**The W Nursing School
Neshoba General
Philadelphia, MS**

Addendum No. 2

June 10, 2026

This addendum forms a part of the contract documents and modifies the original plans and specifications dated June 4, 2026.

sheet no.
A-501
of

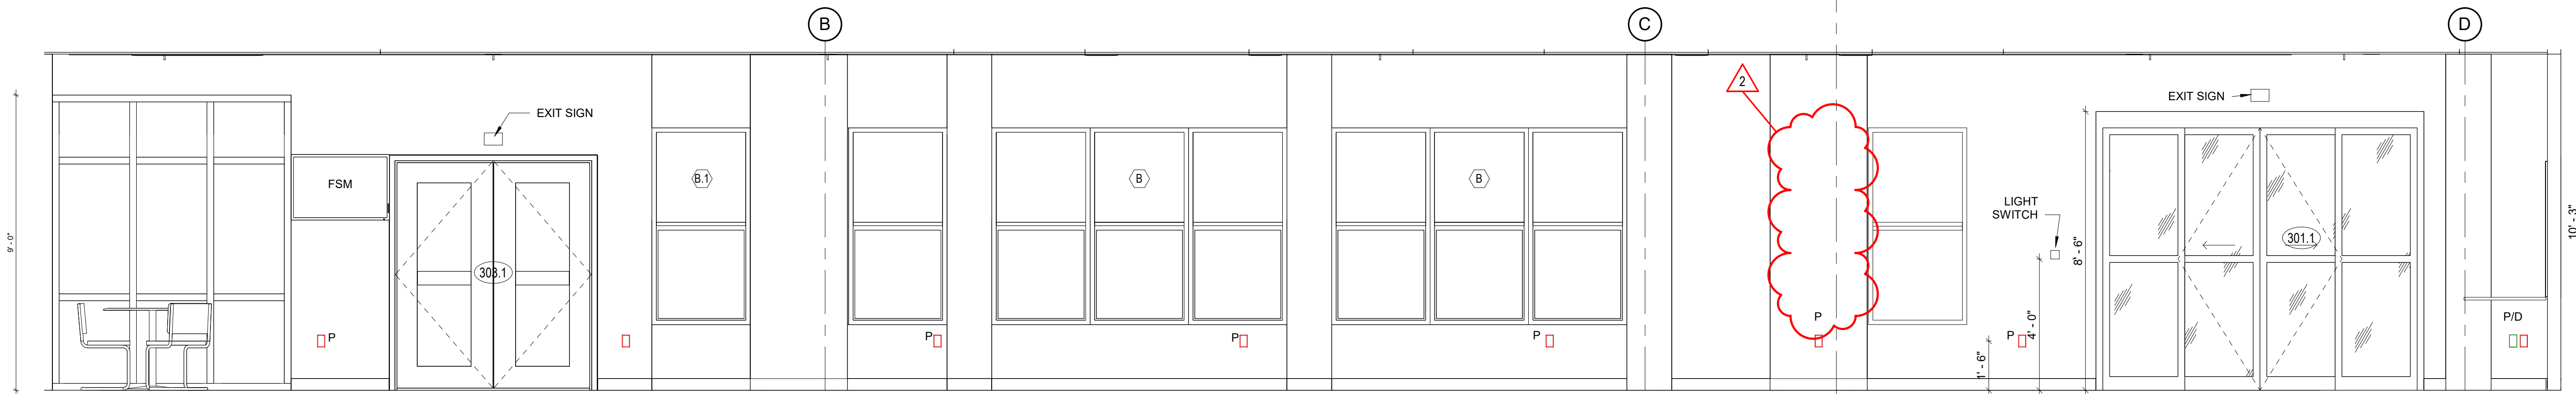
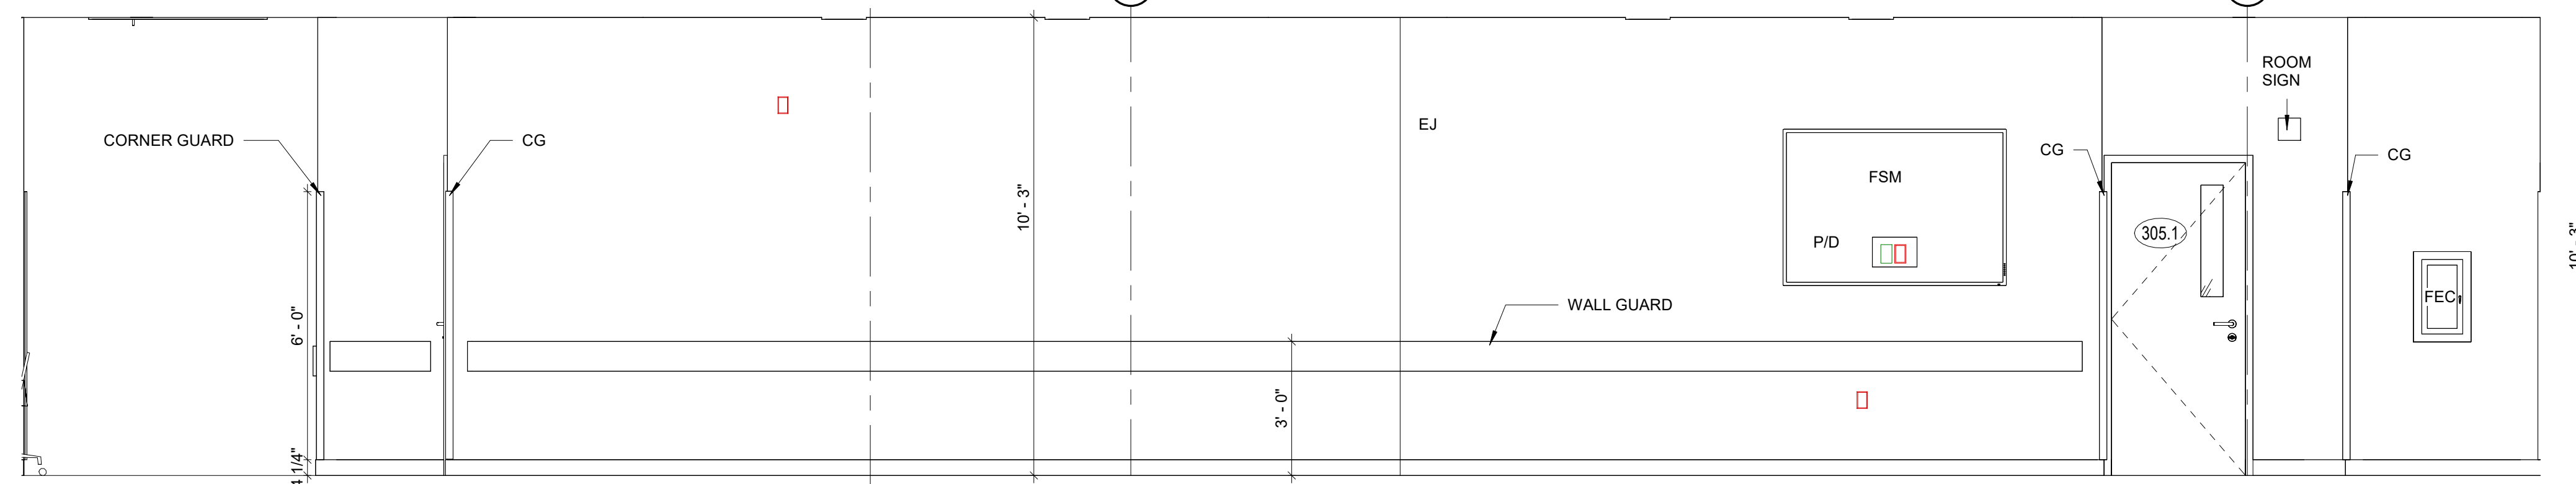
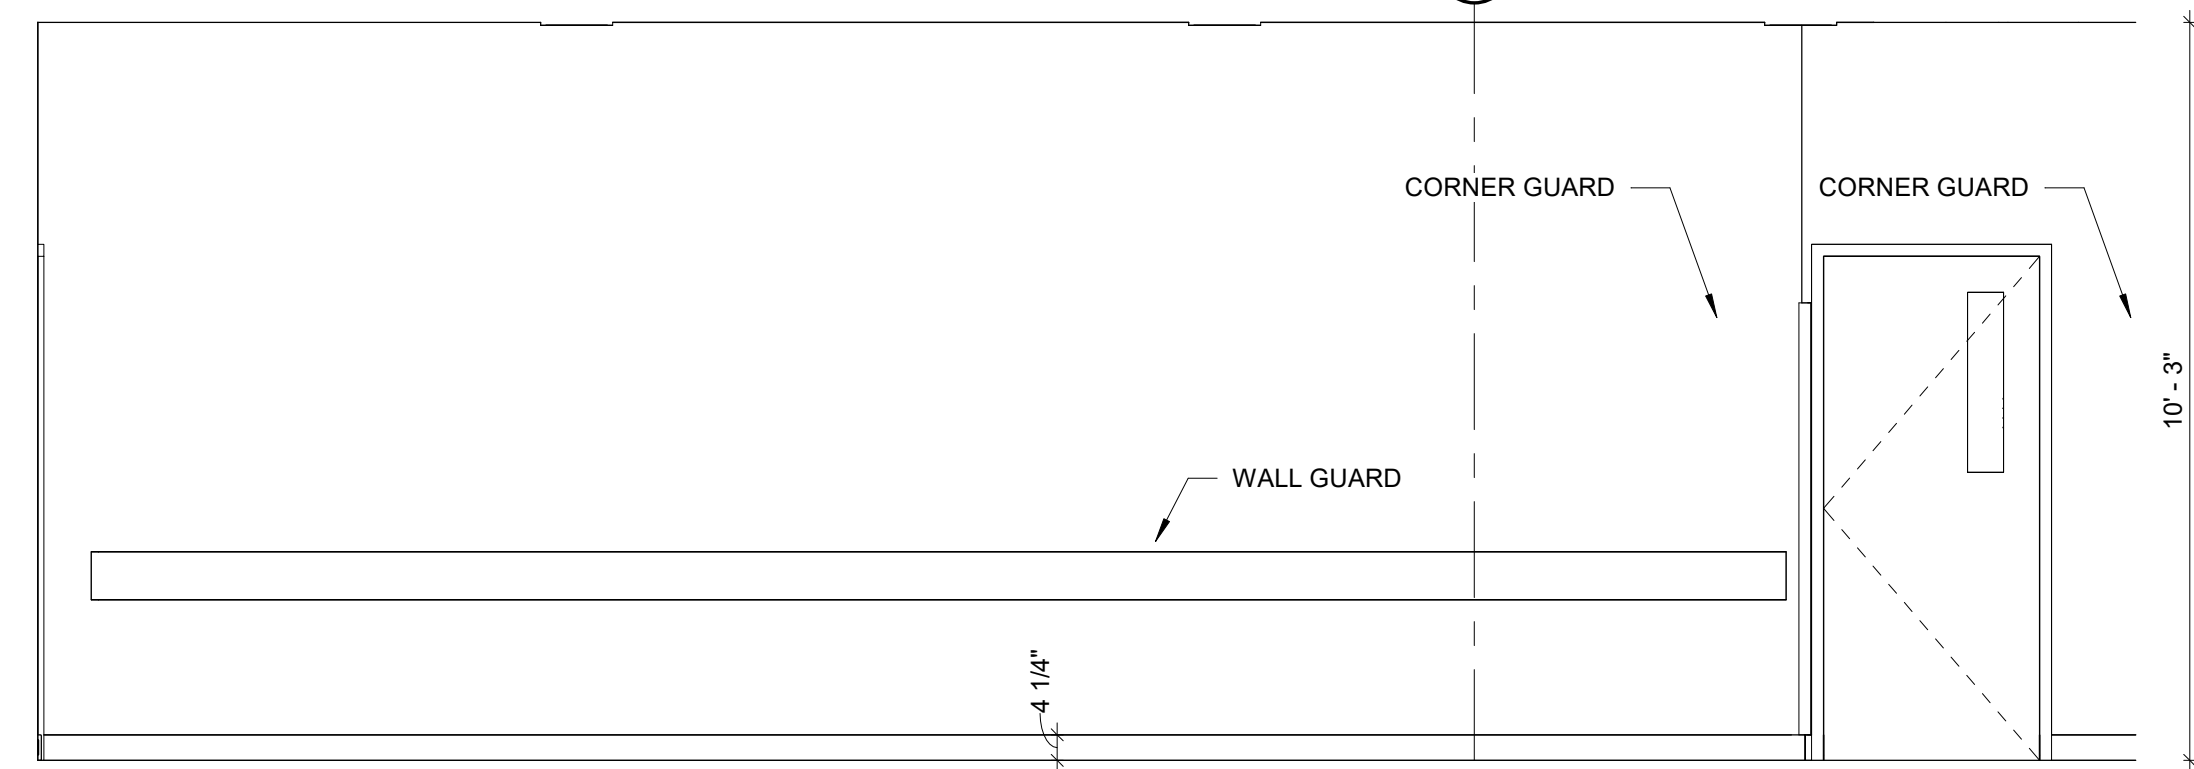
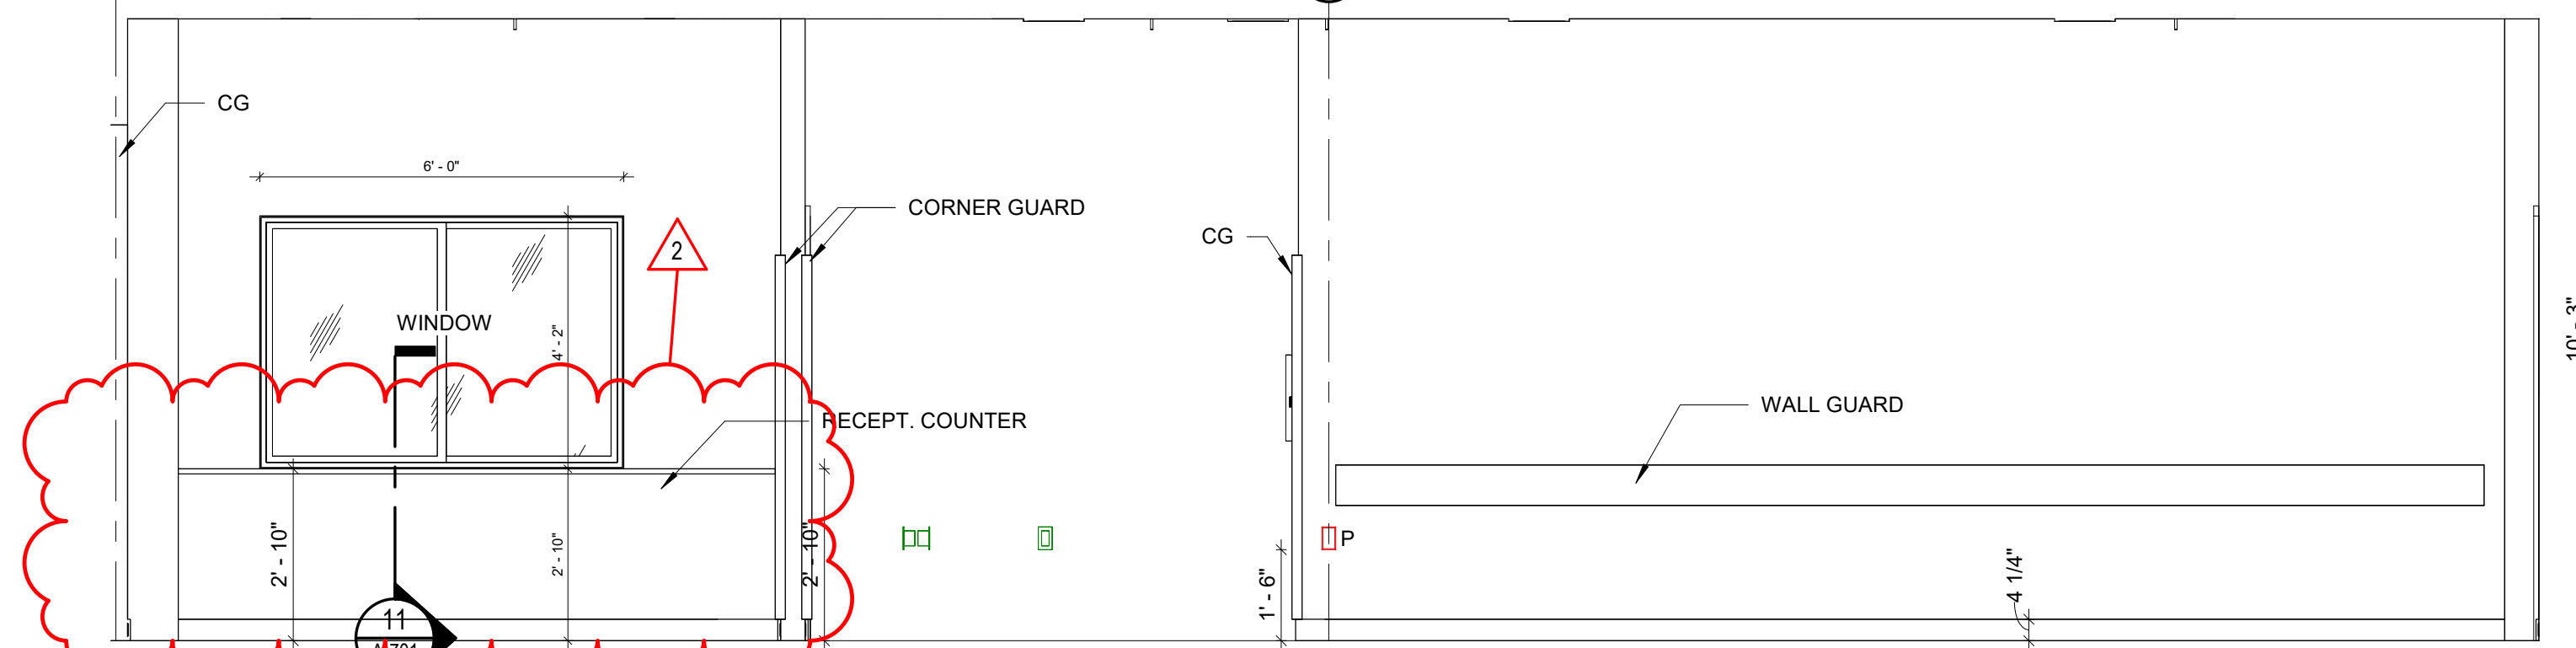
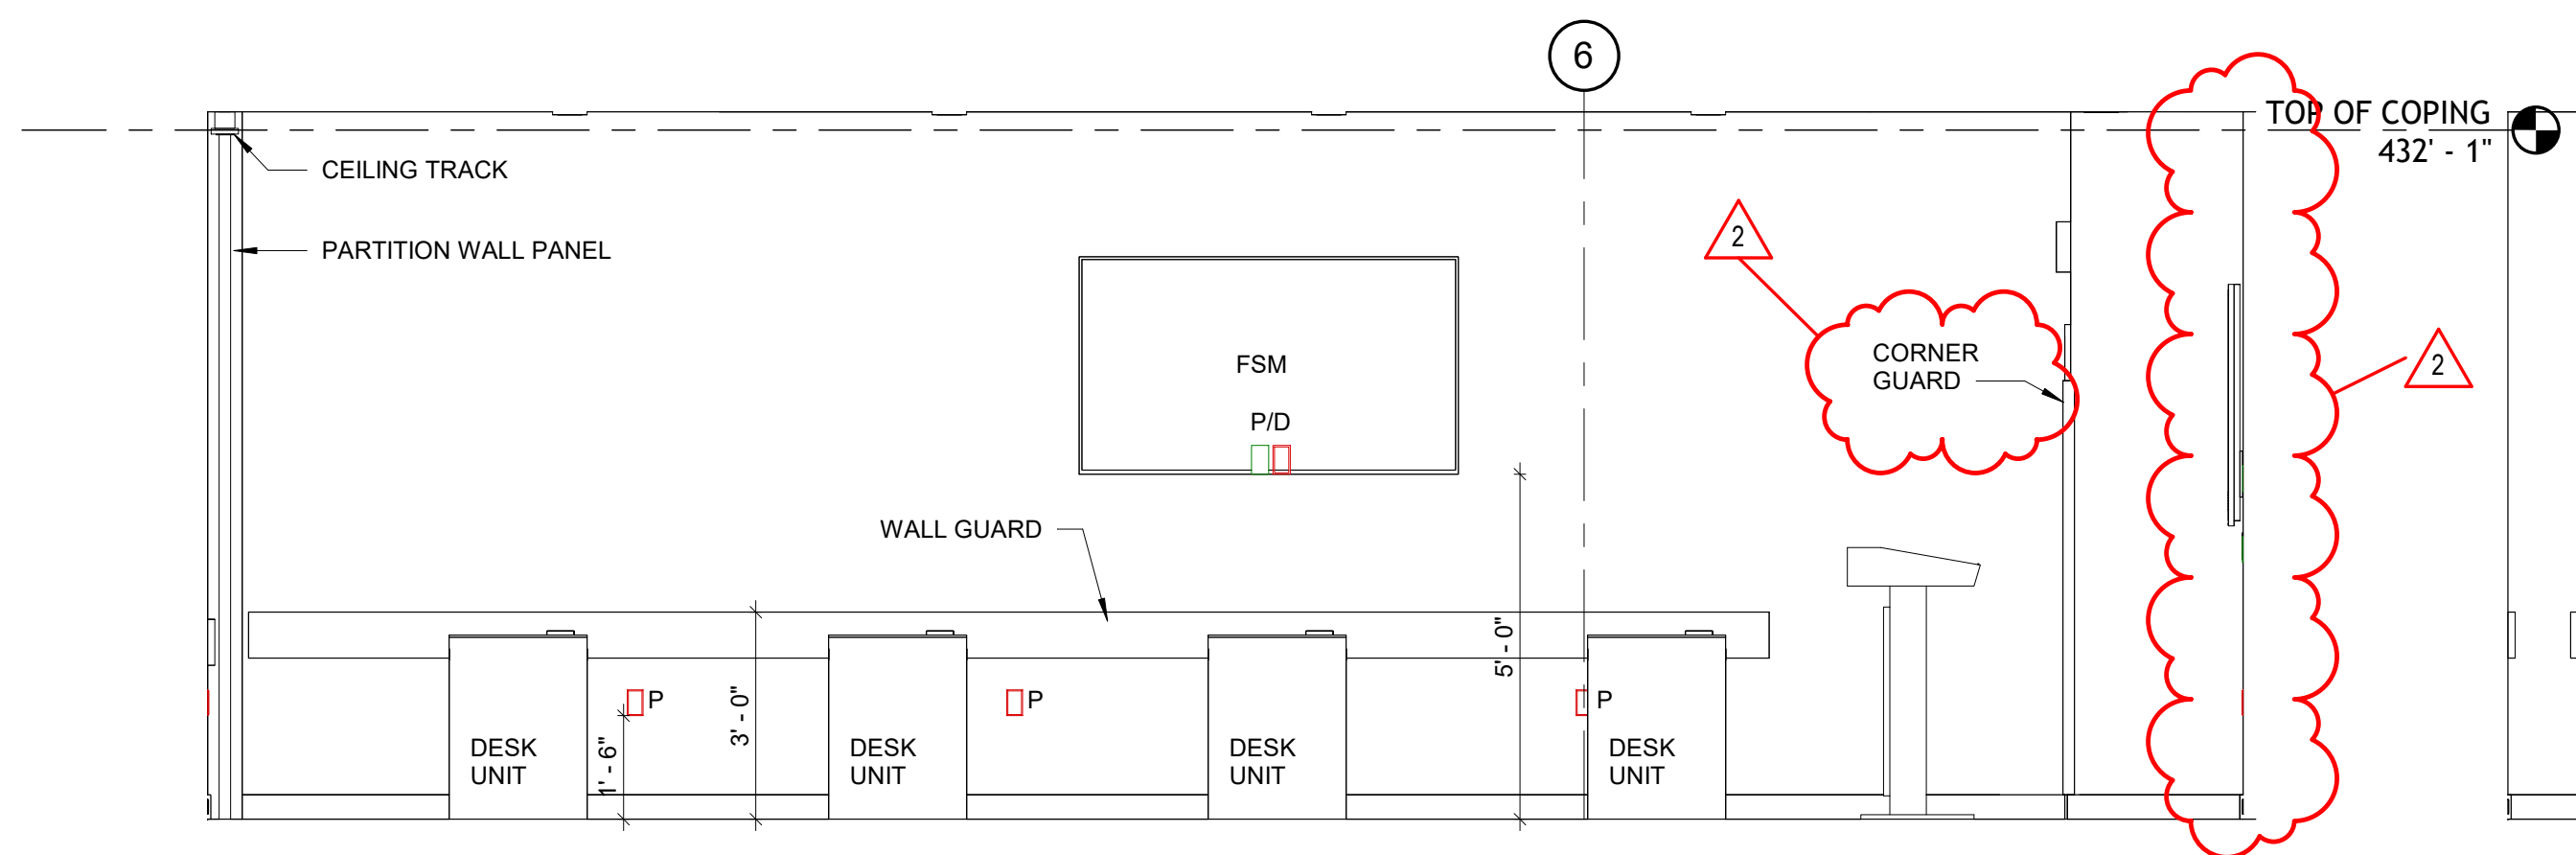
Item 2.9: Sheet A-501

Note: See clouded millwork detail references.
